# Access Compliance Report

## Public Rights-of-Way

Intersection ID: 16765	Main Street: CHURCHILL_RD	Cross Street: N_WENDOVER_RD	Location: SE
ADA ID: DD6D54CED84C	Ramp Type: PerpDiag	Initial Pass/Fail: Fail	Overall Compliance: No
Severity Score: 25			
Codes/Mitigation Info/Possible Solution		Field Measurements/Component Compliance

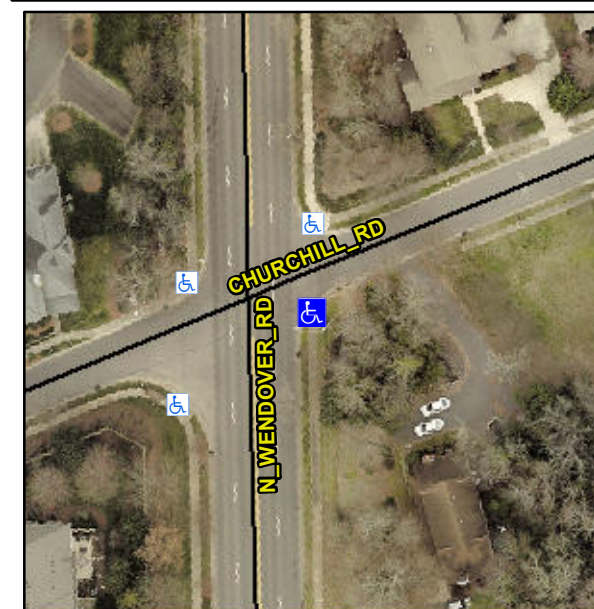
**Not Found, R304.2.2, R304.5.3**

Compliance	Description	Data	Compliance	Description	Data
N/A	Ramp Length (in)	67.0	No	Ramp Slope (%)	10.1
Yes	Ramp Width (in)	48.0	No	Ramp XSlope (%)	5.4
N/A	Flare Type LT	N/A	N/A	Flare Type RT	N/A
N/A	Flare Slope LT (%)	N/A	N/A	Flare Slope RT (%)	N/A
N/A	Flare Traversable LT?	N/A	N/A	Flare Traversable RT?	N/A
N/A	Landing Length (in)	N/A	N/A	DWS Provided?	N/A
N/A	Landing Width (in)	N/A	N/A	DWS Contrast?	N/A
N/A	Landing Slope (%)	N/A	N/A	DWS Length (in)	N/A
N/A	Landing X Slope (%)	N/A	N/A	DWS Full Width?	N/A
N/A	Landing Curb? (Y/N)	N/A	N/A	DWS Offset (in)	N/A
N/A	Shared Landing?	N/A			
N/A	Gutter Ponding?	N/A	N/A	Gutter Slope (%)	N/A
N/A	Gutter Lip Ht (in)	N/A	N/A	Gutter X Slope (%)	N/A
N/A	Painted X Walk1?	No	N/A	Painted X Walk2?	No
	X Walk 1 Direction	To NE		X Walk 2 Direction	To SW
N/A	X Walk 1 Width (in)	N/A	N/A	X Walk 2 Width (in)	N/A
	X Walk 1 Slope (%)	1.6		X Walk 2 Slope (%)	2.0
	X Walk 1 X Slope (%)	2.1		X Walk 2 X Slope (%)	4.0

**Remove & Replace Curb Ramp With Two New Directional Ramps or Equivalent.**
